# UNITED STATES PATENT AND TRADEMARK OFFICE

10/532,183

<b>Office Action Summary</b>	<b>Application No.</b> 10/532,183	<b>Applicant(s)</b> PIERRET ET AL.	
	<b>Examiner</b> Burton S. Mullins	<b>Art Unit</b> 2834

## **DETAILED ACTION**

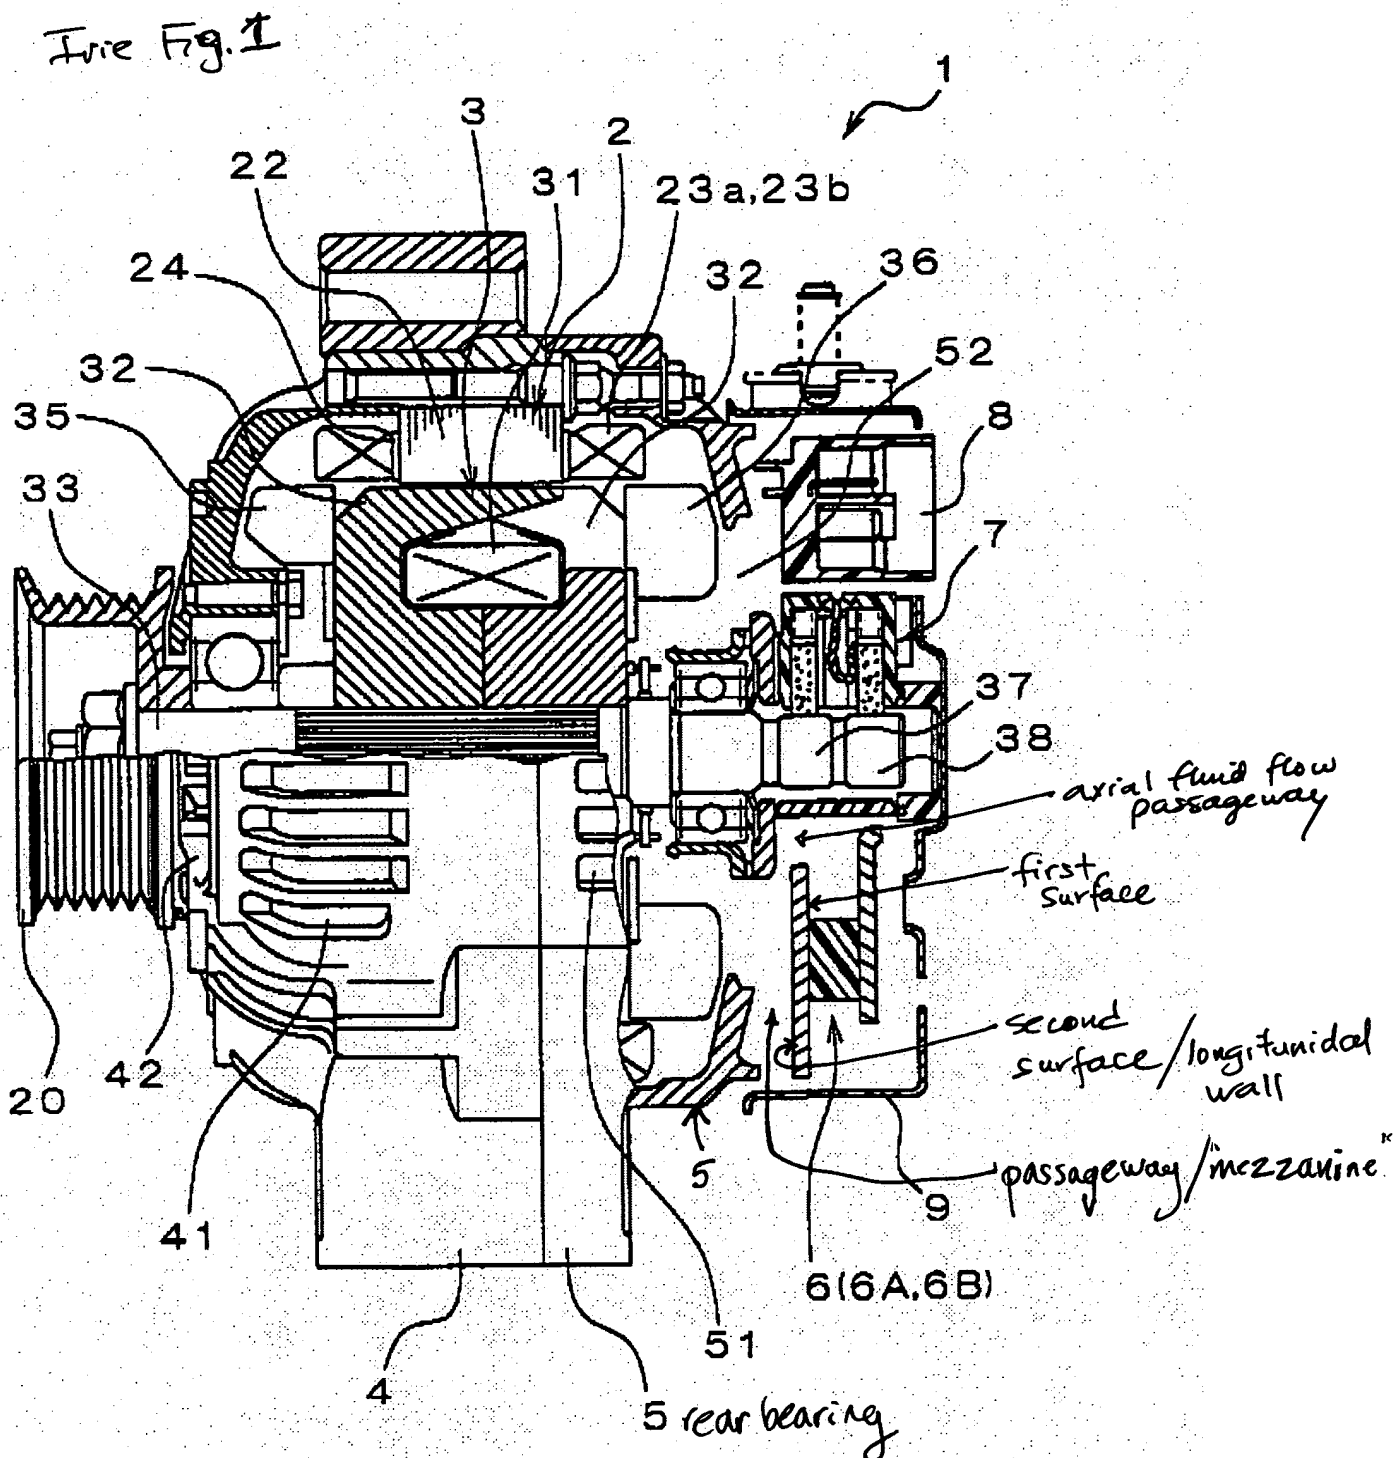
6. Claims 14 and 18 are rejected under 35 U.S.C. 112, second paragraph, as being indefinite for failing to particularly point out and distinctly claim the subject matter which applicant regards as the invention. In claim 14, the term “mezzanine” is vague and indefinite because it is not clear what structural features this term imparts to the claim. For purposes of comparison with the prior art, the term will be interpreted as meaning a space above the rear bearing. In claim 18, the phrase “away from the bearing” is vague and indefinite. It will be interpreted as meaning the fins are separate from the rear bearing.
